SUBJECT: DONALD C. COOK NUCLEAR PLANT, UNITS 1 AND 2 - AMENDMENT NOS. 163 AND 147
TO FACILITY OPERATING LICENSE NOS. DPR-58 AND DPR-74 (TAC NOS. M79834
AND M79835)

SUBJECT: DONALD C. COOK NUCLEAR PLANT, UNITS 1 AND 2 - AMENDMENT NOS. 163 AND 147
TO FACILITY OPERATING LICENSE NOS. DPR-58 AND DPR-74 (TAC NOS. M79834
AND M79835)

SAFETY EVALUATION BY THE OFFICE OF NUCLEAR REACTOR REGULATION
RELATED TO AMENDMENT NO. 163 TO FACILITY OPERATING LICENSE NO. DPR-58
AND AMENDMENT NO. 147 TO FACILITY OPERATING LICENSE NO. DPR-74

FIGURE 5.6-1

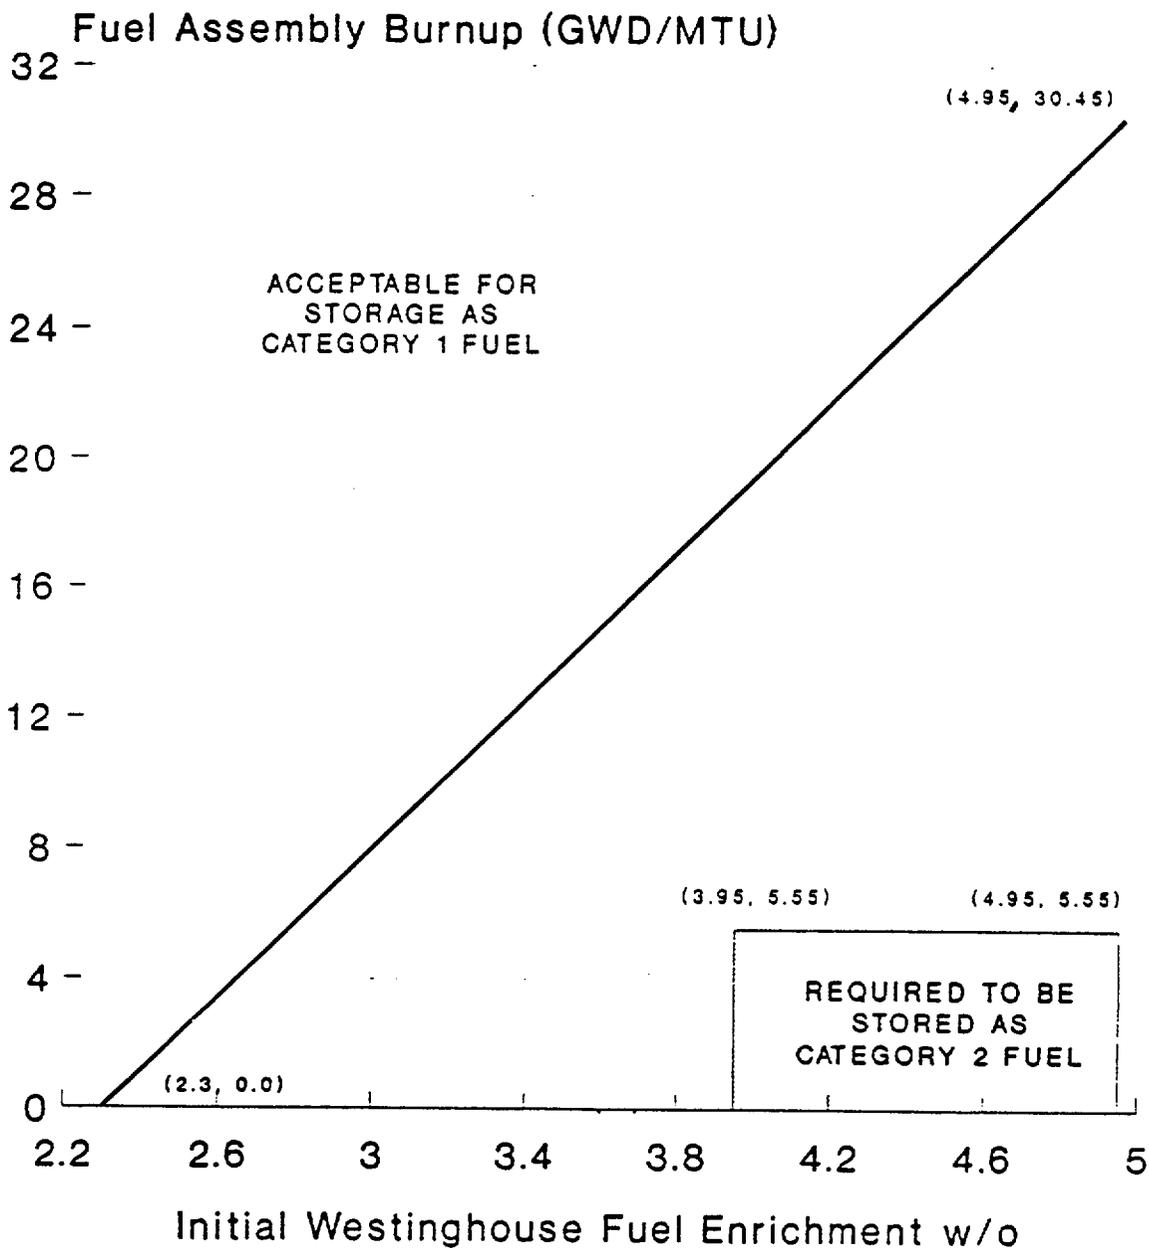
- 1) TS 5.6.1.1.c.1 identifies Region 1 of the spent fuel pool for storage of Westinghouse fuel types with nominal fuel assembly enrichments of 3.95 w/o or greater. Fuel stored in Region 1 must be stored in a checkerboard configuration alternating Westinghouse Category 1 and Category 2 fuel, as shown in TS Figure 5.6-1. Category 1 and Category 2 fuel are defined in TS Figure 5.6-2.

- 2) TS 5.6.1.1.c.2 identifies Region 2 of the spent fuel pool. This Region is for the storage of Westinghouse fuel with an enrichment less than or equal to 3.95 w/o U-235 or with an enrichment greater than 3.95 w/o U-235 but with a burnup greater than or equal to 5,550 MWD/MTU, and ANF fuel of an enrichment less than or equal to 4.23 w/o U-235 for a 17x17 assembly or less than or equal to 3.50 w/o U-235 for a 15x15 assembly.
- 3) TS 5.6.1.1.c.3 addresses the boundary condition between Regions 1 and 2 and requires that the checkerboard pattern for Region 1 must be carried into Region 2 by at least one row. This is illustrated in revised TS Figure 5.6-1.

- a. A k_{eff} equivalent to less than 0.95 when flooded with unborated water,
- b. A nominal 10.5 inch center-to-center distance between fuel assemblies placed in the storage racks.
- c. 1. A separate region within the spent fuel storage racks (defined as Region 1) shall be established for storage of Westinghouse fuel types of enrichments greater than 3.95 weight percent U-235 and burnup less than 5,550 MWD/MTU in a checkerboard pattern configuration alternating Category 1 and Category 2 fuel as shown in Figure 5.6-1.

2. A separate region within the spent fuel storage racks, defined as Region 2, shall be established for storage of Westinghouse fuel of an enrichment less than or equal to 3.95 weight percent U-235 or an enrichment greater than 3.95 weight percent U-235 but with a burnup greater than or equal to 5,550 MWD/MTU, and Exxon/ANF fuel of an enrichment less than or equal to 4.23 weight percent U-235 for a 17 x 17 assembly or less than or equal to 3.50 weight percent U-235 for a 15 x 15 assembly.
3. The boundary between the Regions 1 and 2 mentioned above shall be such that the checkerboard pattern storage requirement of Region 1 shall be carried into Region 2 by at least one row as shown in Figure 5.6-1.
